Subject: PPR-17-055 2nd Review

SHOPS AT MCLAUGHLIN II

DEVELOPMENT PLAN

1 of 11 SITE PLAN

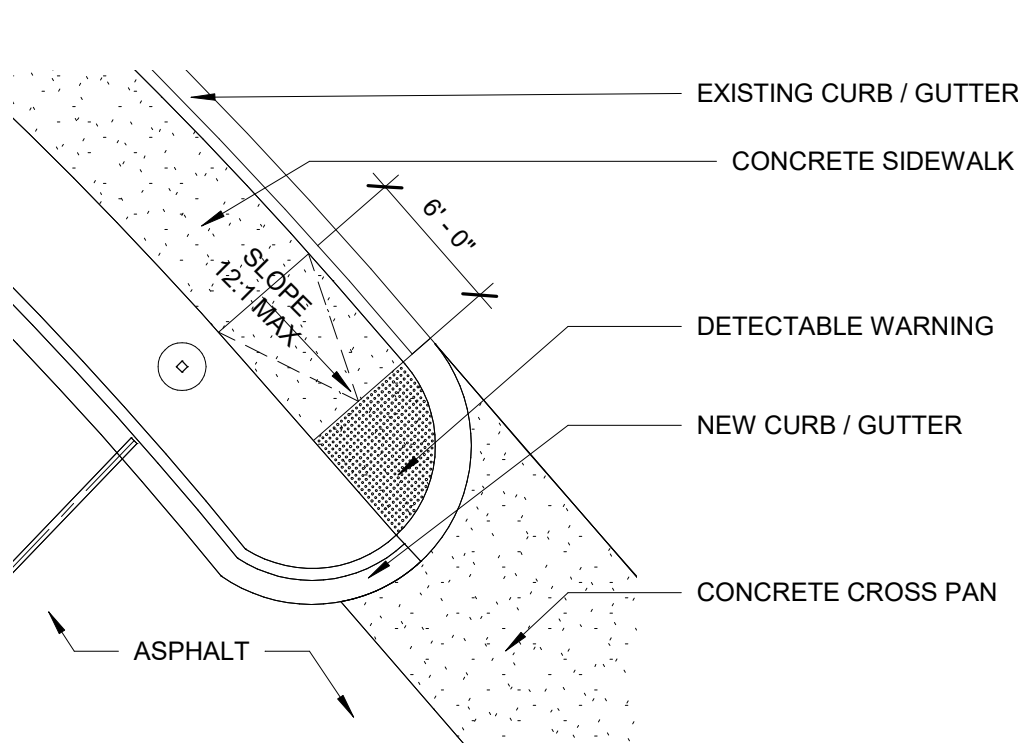
Change the title to Grading and Erosion Plan

Remove the proposed drainage map from the site development plan set and include the drainage map in the drainage report.

Neither the Plat or Lot 5 site plan identify a cross access drive. A cross access agreement and offsite improvement with the adjacent owner must be obtained. Provide a copy to the County.

Title has been revised.

Sheet has been removed.

Adjacent property is owned by the same entity. However the cross access has been removed.

8 SITE-CURB/GUTTER @ SIDEWALK
DP 2 1" = 1'-0"

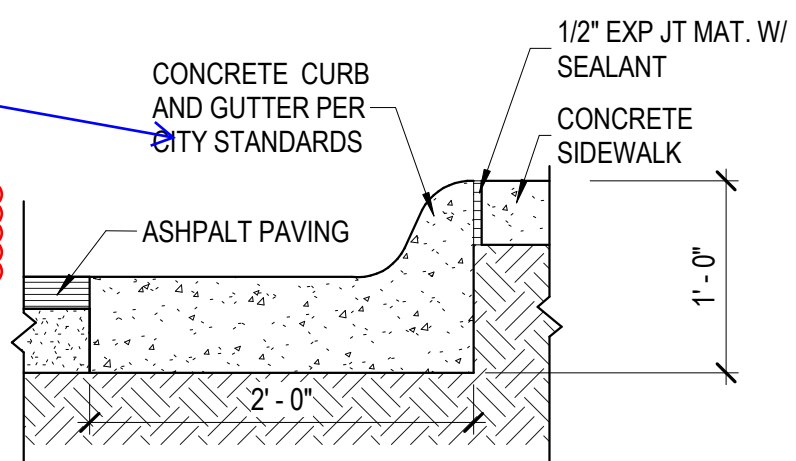
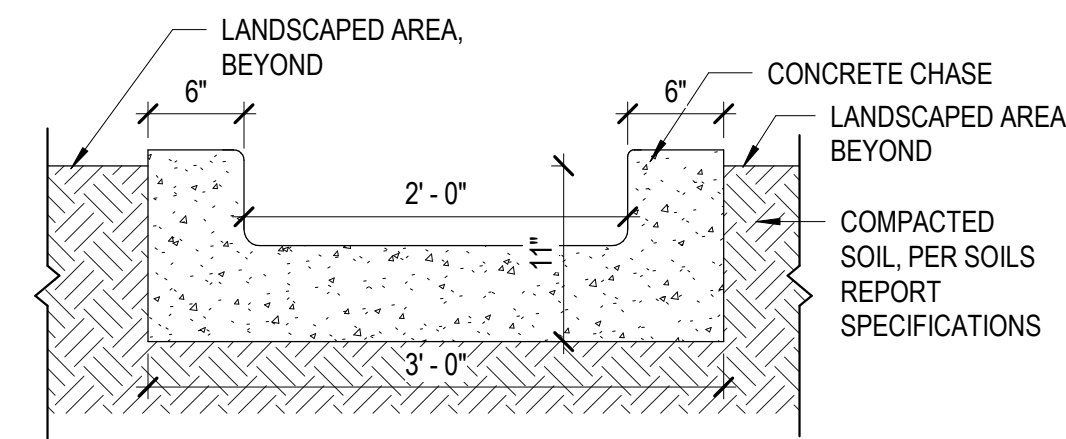
County Standards.
Identify the specific
C&G type. See detail
SD_2-20

Note has been revised.

DATE	2/22/18
CHECKED	LD
DRAWN BY	JF
PRELIMINARY UTILITIES AND PUBLIC FACILITIES PLAN	
C1

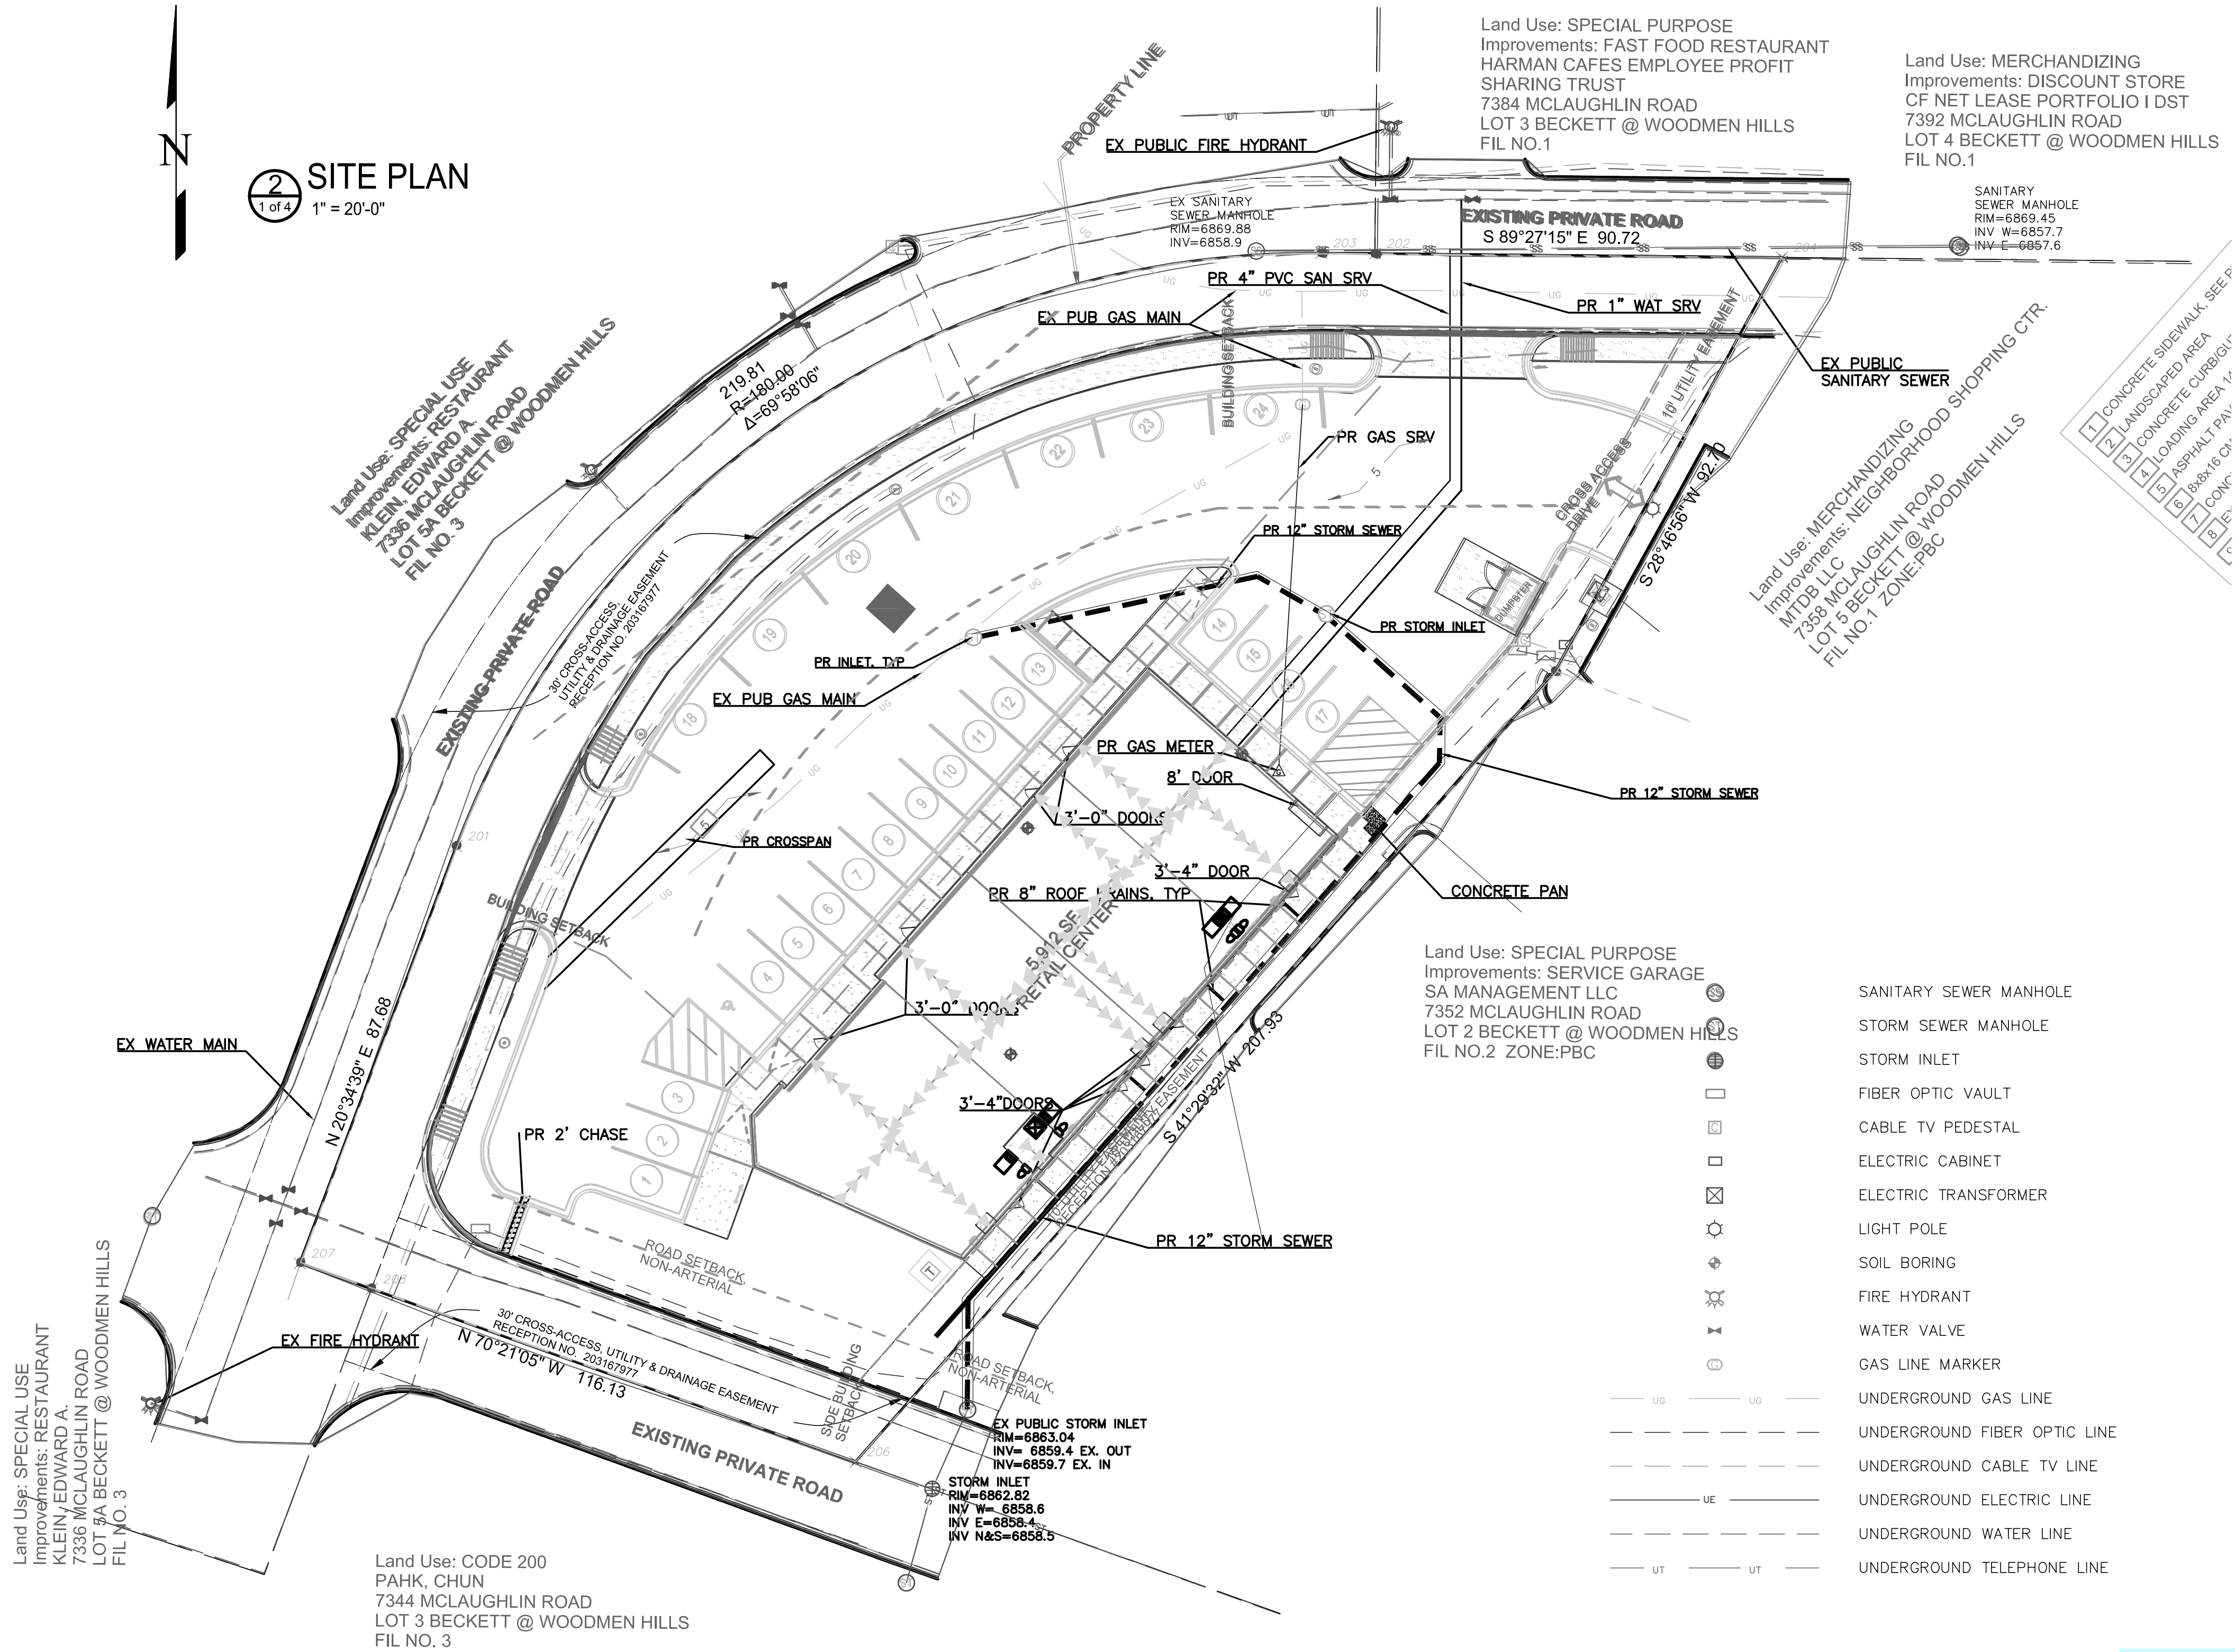
Add the bmp symbols
on the legend.

Information has been
added to the drawing.

Information has been
added to the legend.
